### ADDENDUM NO. 3

PROJECT: Birmingham Public Schools

DESCRIPTION: West Maple French School Remodeling

DATE: December 15, 2017		
	PROJECT: West Maple Elementary French School Remodeling		
	TMP PROJECT NO.: 15104A		
	ADDENDUM NO.: Three (3) BID PACKAGE NO.:5		
	ADDENDUM NO. 1 WAS PREVIOUSLY ISSUED ON DECEMBER 13, 2017 ADDENDUM NO. 2 WAS PREVIOUSLY ISSUED BY THE CONSTRUCTION MANAGER.		
	ocuments are modified, supplemented or augmented as follows and this Addendum is hereby made a losed Contract Documents.		
The following D	Drawings and Attachments are issued with this Addendum.

**A1.1D**

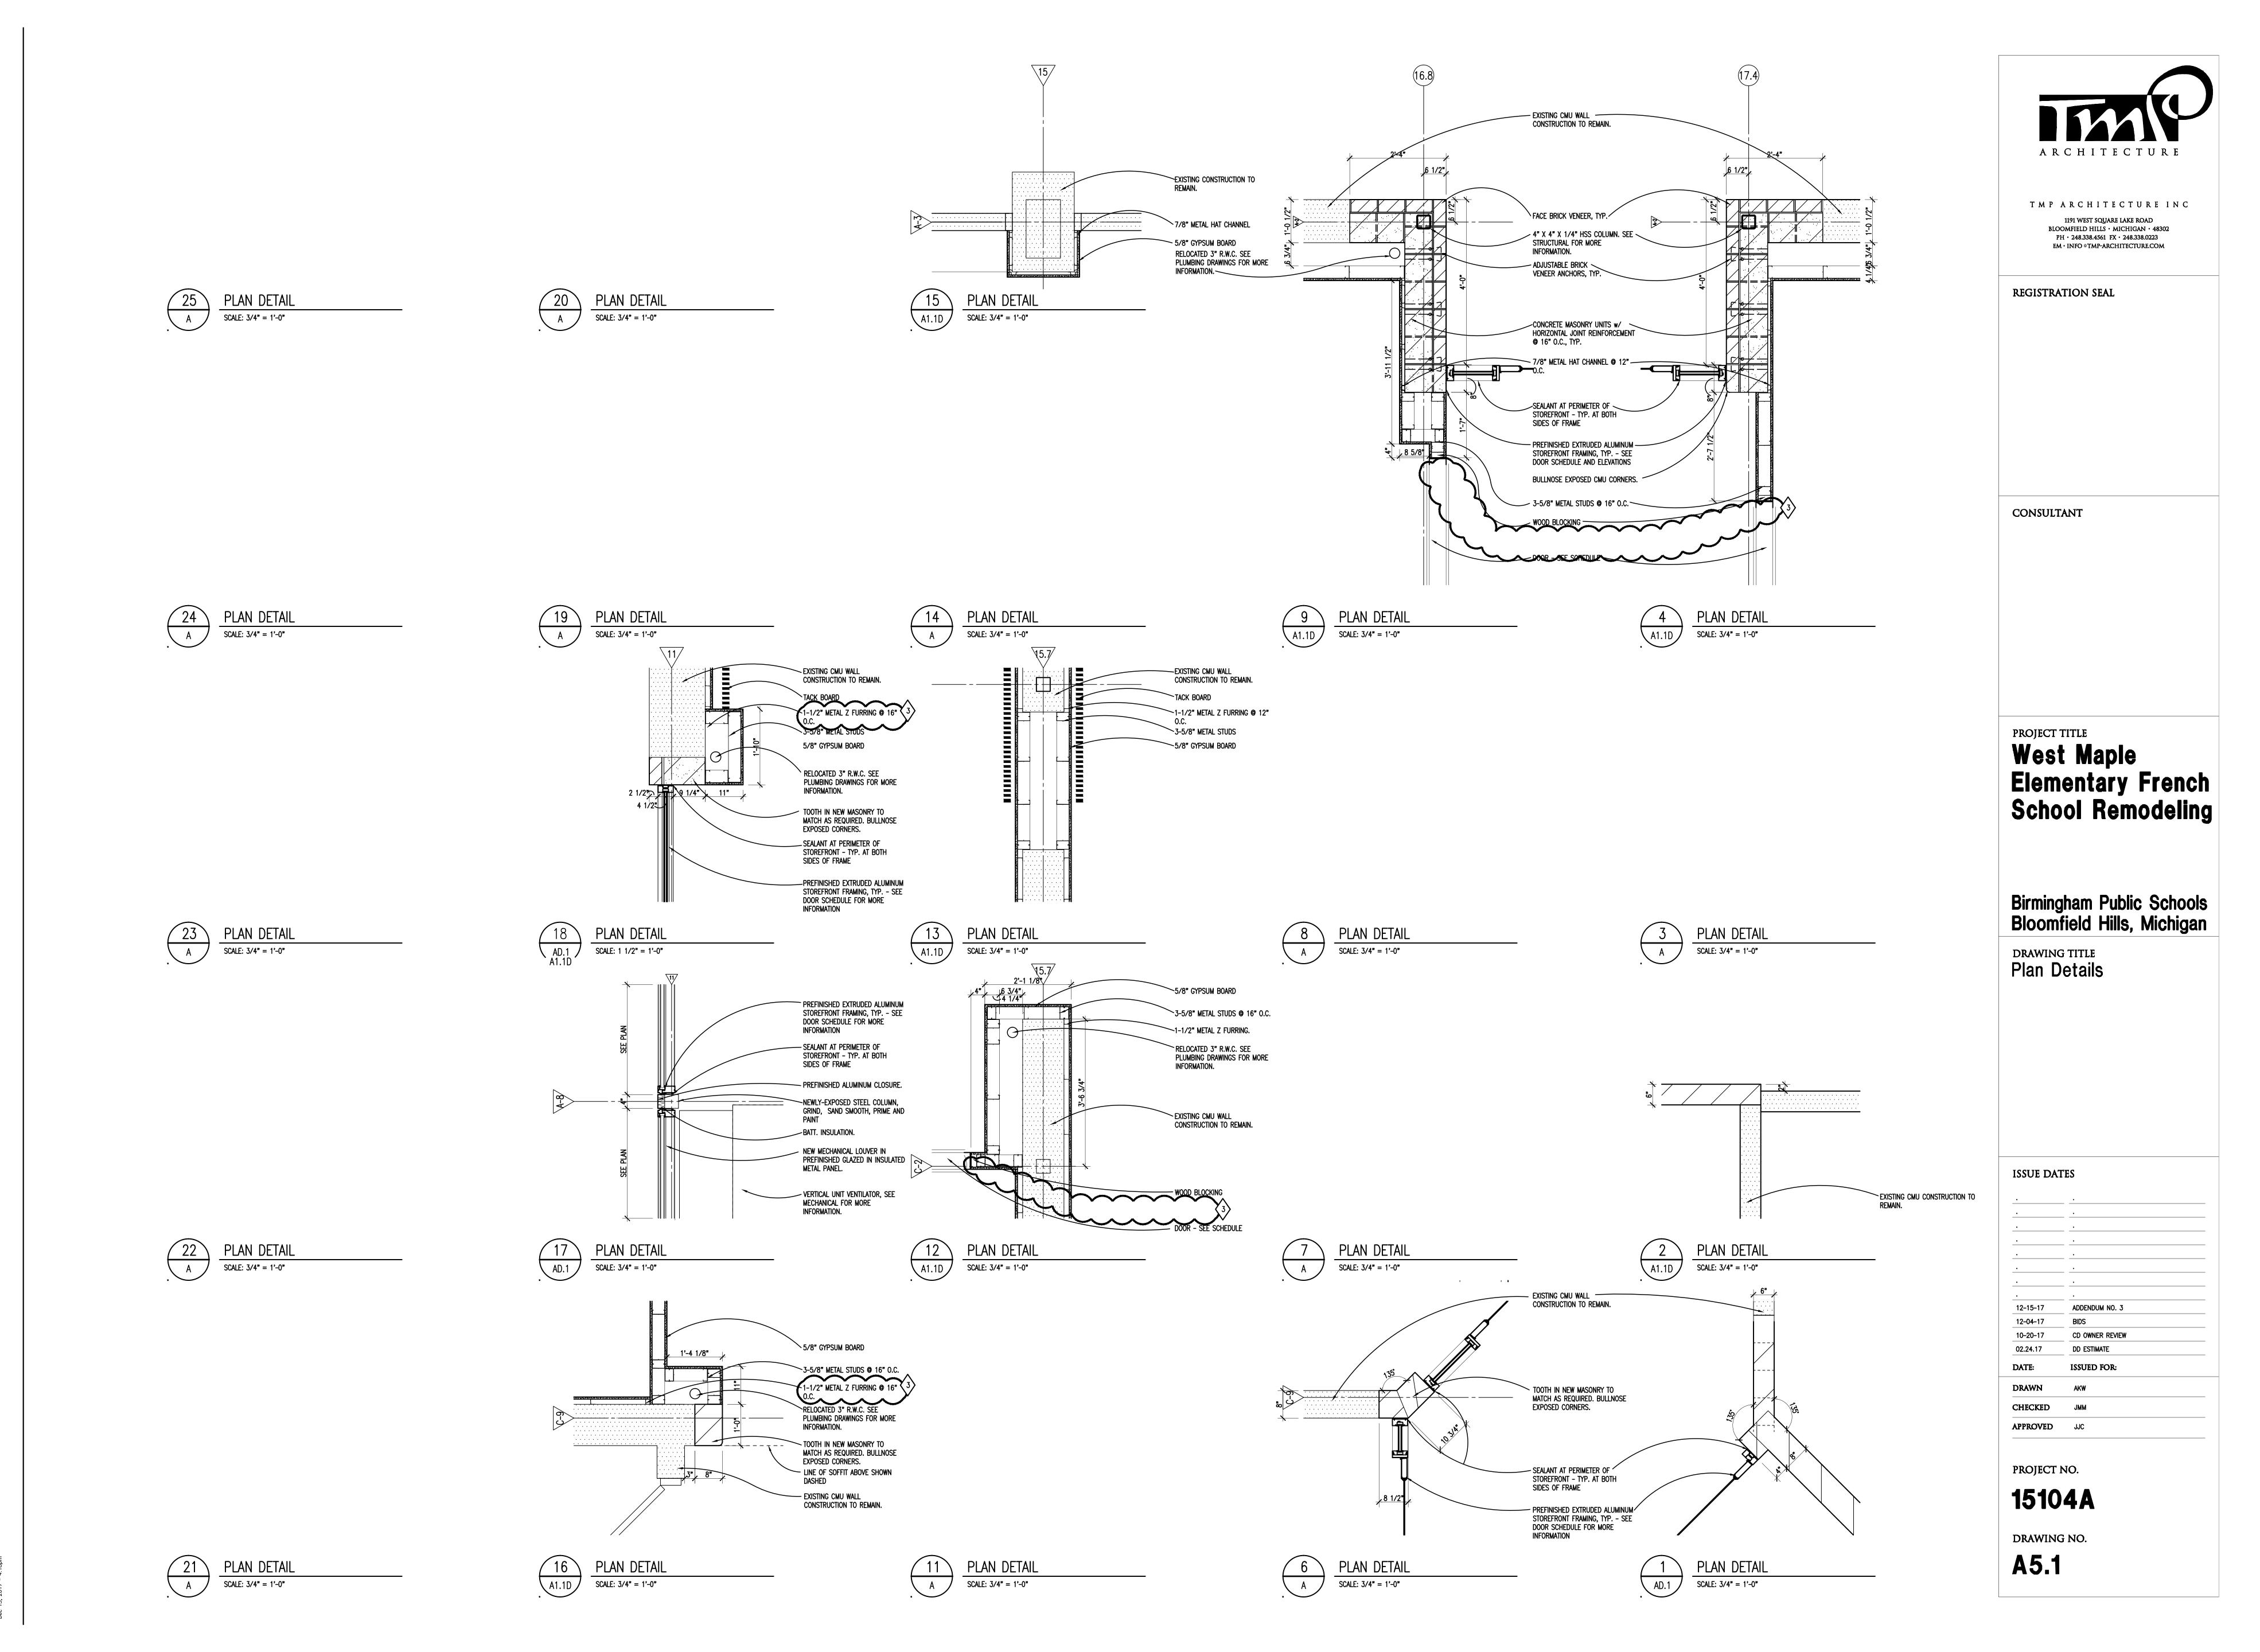
a. RFI Question: Refer to A1.1D. The exterior of Rooms D105 & D108 have a wall tag of 1H, which is 1-1/2" Z furring 16" oc. Details 16&18/A5.1 call for the z furring to be 12" oc. Please clarify.

b. RFI Question: Are the walls in all bathrooms to receive Ceramic Tile as noted on Sheet A1.1D Wall Note 1B or are we to follow Sheet A10.1D (Epoxy Paint). If it is Ceramic Tile we will need specification for the product.

- AD-1 Refer to Drawing No. A1.1D (reissued):
  - A. Refer to Wall/Partition Legend 1B. Modified 1B to read, "4" GALVANIZED METAL STUDS AT 16" ON CENTER (MAX) WITH 3" ACOUSTIC BATT INSULATION FULL HEIGHT. ON SIDE SCHEDULED TO RECEIVE EPOXY FINISH PROVIDE 5/8" MOISTURE RESISTANT GYPSUM BOARD FROM FLOOR TO 4" ABOVE HIGHEST ADJACENT CEILING. ON SIDE NOT SCHEDULED TO RECEIVE EPOXY FINISH PROVIDE 5/8" GYPSUM BOARD EXTENDING FROM FLOOR TO 4" ABOVE HIGHEST ADJACENT CEILING. BRACE TO ADJACENT WALLS AS REQUIRED."

- B. Refer to Wall/Partition Legend 1D. Modified 1D to read, "PROVIDE 5/8" MOISTURE RESISTANT GYPSUM BOARD ONE SIDE, HEIGHT: FROM TOP OF FLOOR TO 4" ABOVE HIGHEST ADJACENT CEILING. BRACE TO ADJACENT WALLS AS REQUIRED."
- AD-2 Refer to Drawing No. A5.1 (reissued):
  - A. Refer to Details 4, 9 & 12/A5.1. Removed note for wood trim as indicated.
  - B. Refer to Details 16 & 18/A5.1. Modified note to read, "1 ½" metal z furring @ 16" O.C."
- AD-3 Refer to Drawing No. A9.1D (reissued):
  - A. Refer to Room D106. Added casework tag where indicated.
- AD-4 Refer to Drawing No. A10.1D (reissued):
  - A. Refer to Finish Tags for rooms D107, D109, D122 & D125. Modified floor and base type to trolled epoxy.
  - B. Refer to Finish Legend Base and Wall abbreviations. Added TREP, trolled epoxy as indicated.

TMP Response: 16" o.c. 16&18/A5.1 will be modified to reflect [Anna Read – TMP Architecture, Inc. – 12/15/17]

TMP Response: Epoxy paint. [Anna Read – TMP Architecture, Inc. – 12/15/17]

A9.1D

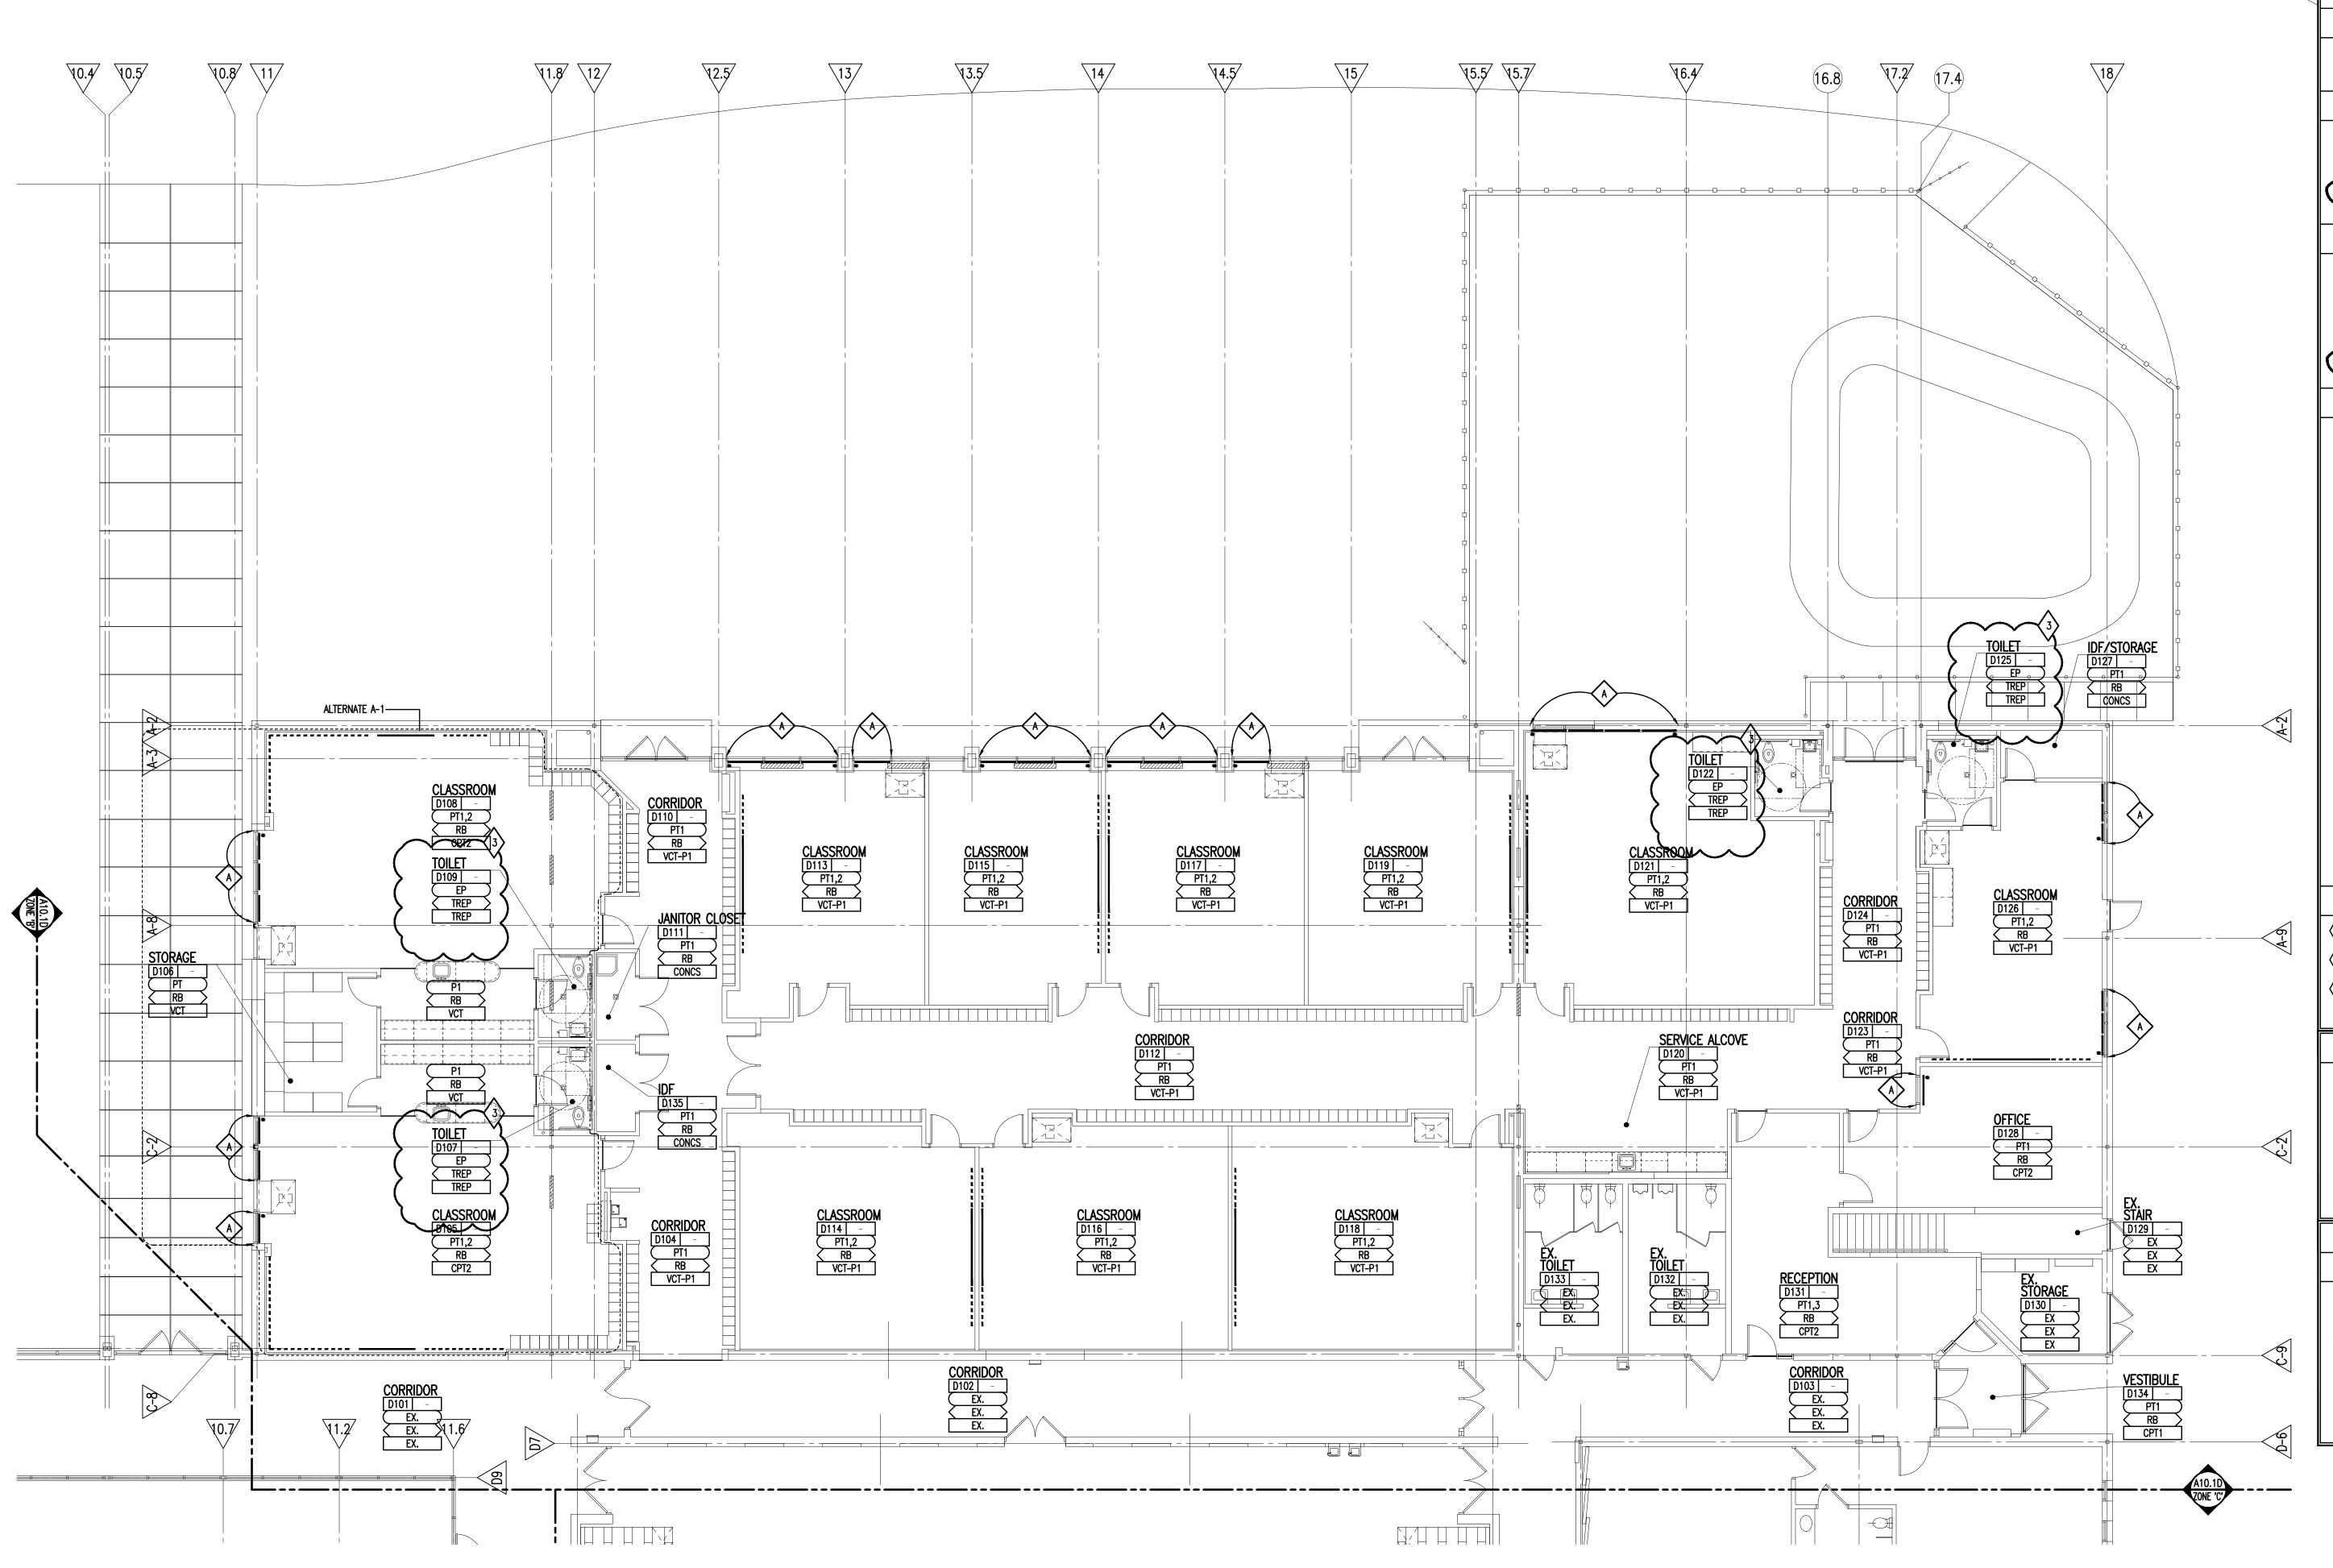
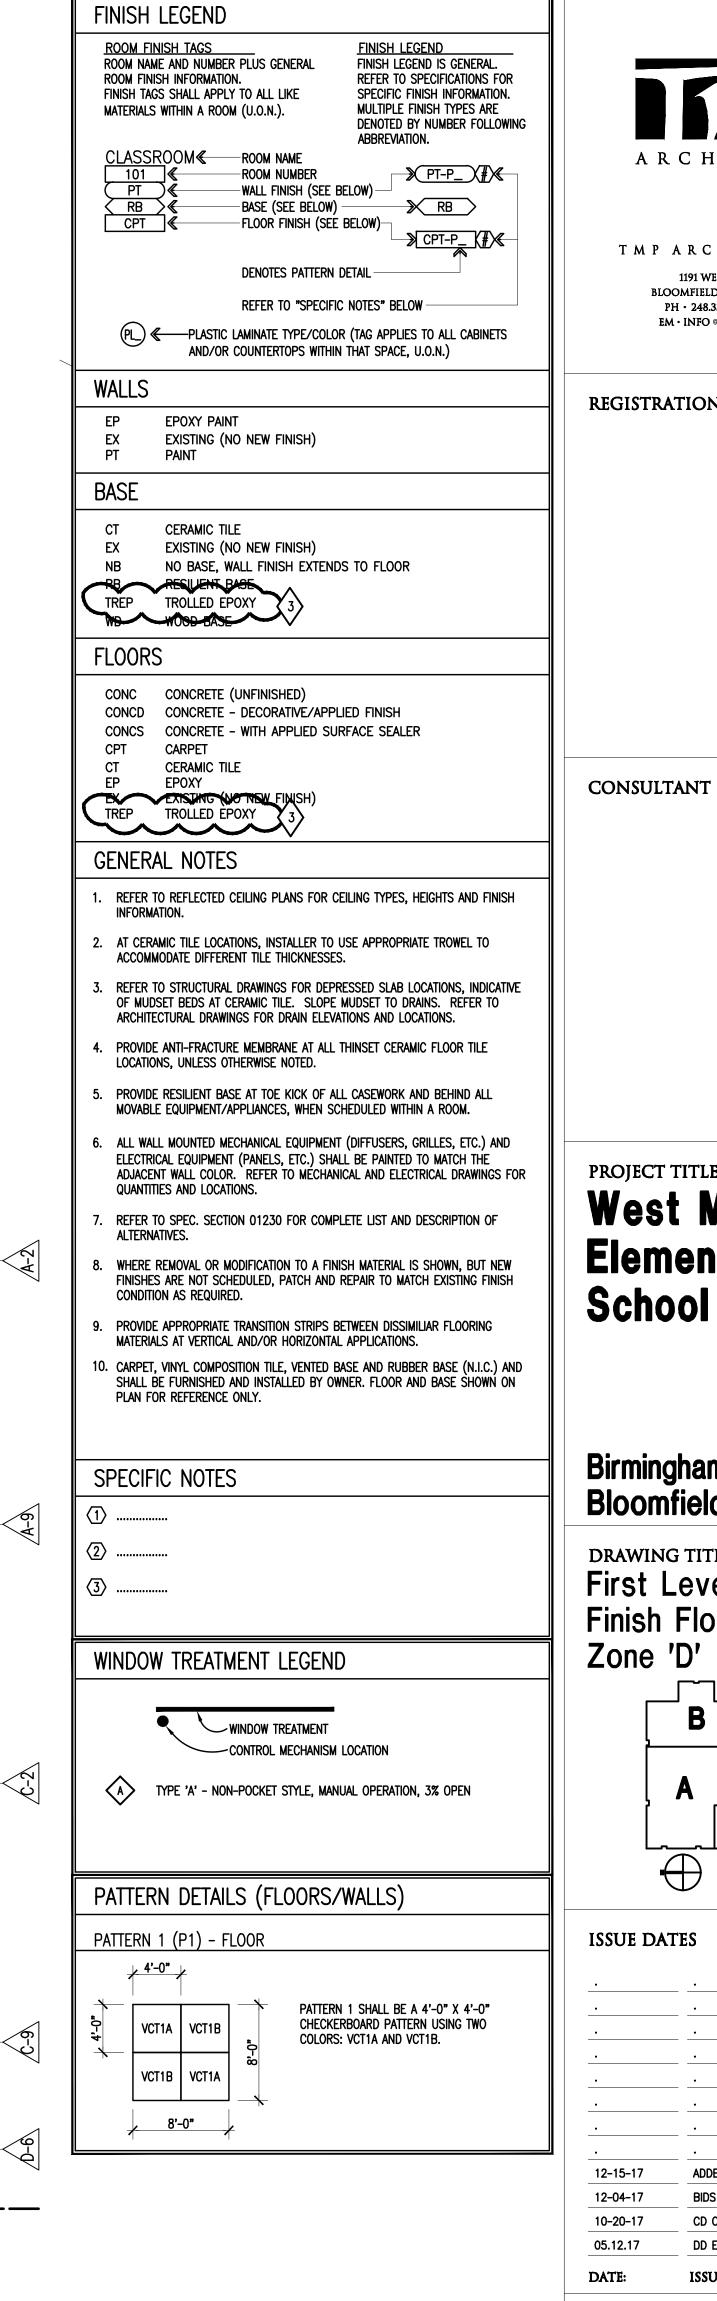
c. RFI Question: Refer to A9.1D. Is the casework in D106 owner furnished?

TMP Response: No, include in bid. [Anna Read – TMP Architecture, Inc. -12/15/17]
